**ZONING AMENDMENT,
PLANNED UNIT DEVELOPMENT &
SUBDIVISION STAFF REPORT**

Date: February 18, 2010

<u>NAME</u>	Goodwyn, Mills & Cawood, Inc.
<u>SUBDIVISION NAME</u>	White Oaks Subdivision
<u>LOCATION</u>	328 Dogwood Drive (Northwest corner of Dogwood Drive and Oak Ridge Road)
<u>CITY COUNCIL DISTRICT</u>	District 5
<u>PRESENT ZONING</u>	R-1, Single-Family Residential District
<u>PROPOSED ZONING</u>	R-2, Two-Family Residential District
<u>REASON FOR REZONING</u>	To allow a single-family residential subdivision with reduced lot sizes and widths, increased site coverage and reduced side yard setbacks.
<u>AREA OF PROPERTY</u>	6 Lots / 1.0± Acres
<u>CONTEMPLATED USE</u>	Subdivision approval to create six legal lots of record from one legal lot; Planned Unit Development Approval to allow a single-family residential subdivision with reduced lot sizes and widths, increased site coverage and reduced side yard setbacks; and Rezoning from R-1, Single-Family Residential District, to R-2, Two-Family Residential District, to allow a single-family residential subdivision with reduced lots sizes and widths, increased site coverage and reduced side yard setbacks. It should be noted, however, that

SUBDIVISION DETAIL

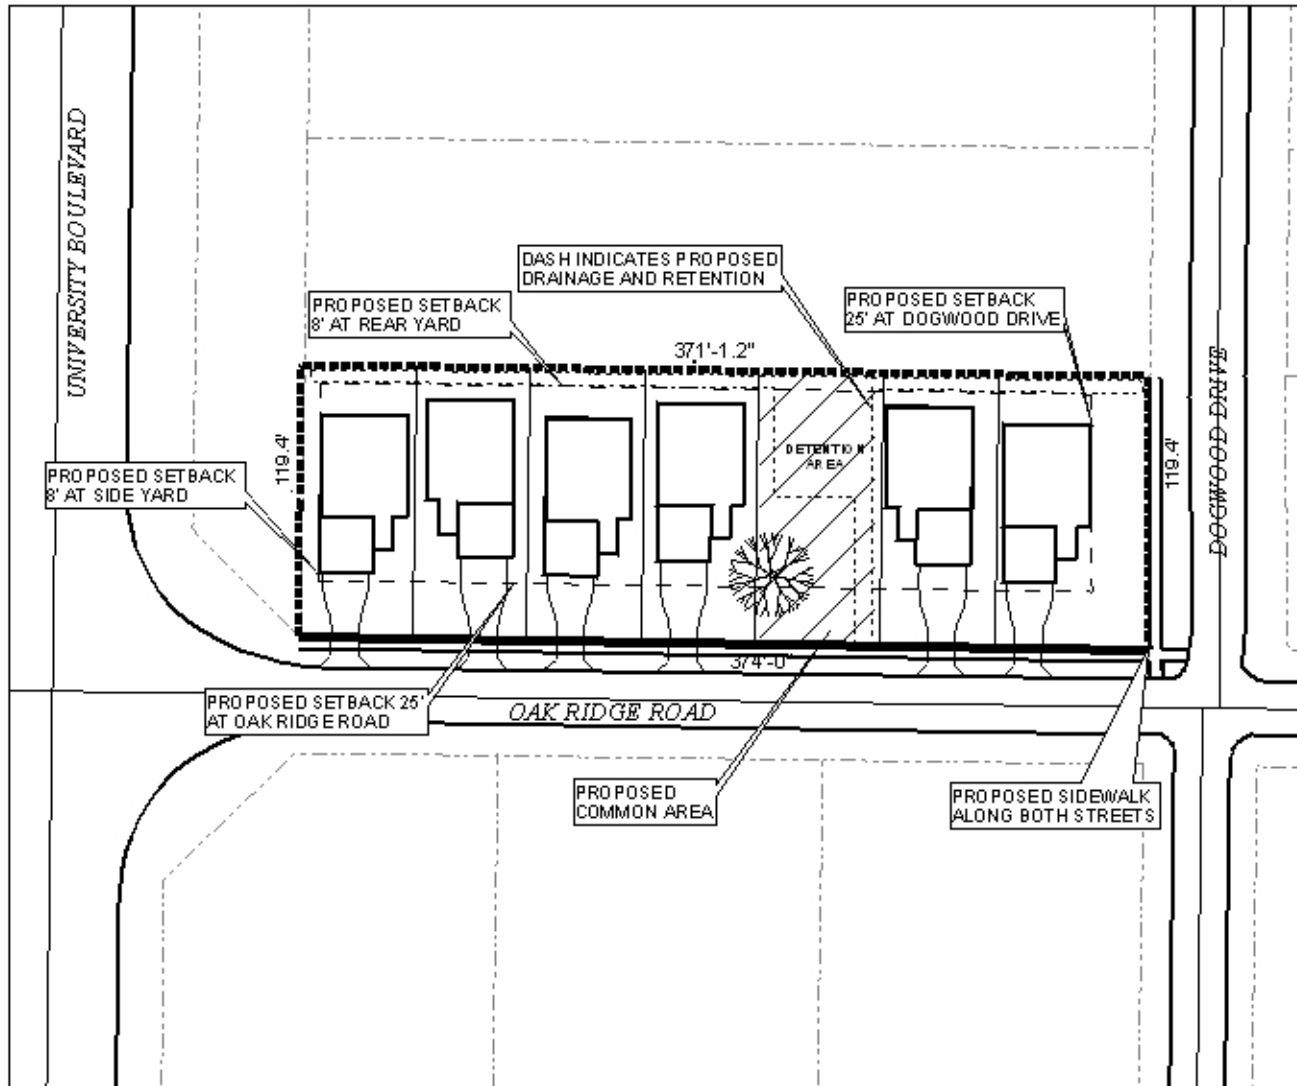
At the corner of Dogwood and Oak Ridge Rd (SE corner of Lot 6), need to dedicate to the City a radius of 25' or as otherwise approved by the City Engineer. Must comply with all storm water and flood control ordinances. Any work performed in the right of way will require a right of way permit.

Driveway number, size, location, and design to be approved by Traffic Engineering and conform to AASHTO standards. The driveway for Lot 1 is located too close to the intersection and should be relocated to the far East side of the lot.

As proposed, the six-lot subdivision within the one-acre area is out of character with the lot sizes of the surrounding neighborhood and clashes with the open space concept of the neighborhood and more particularly, the abutting property to the North.
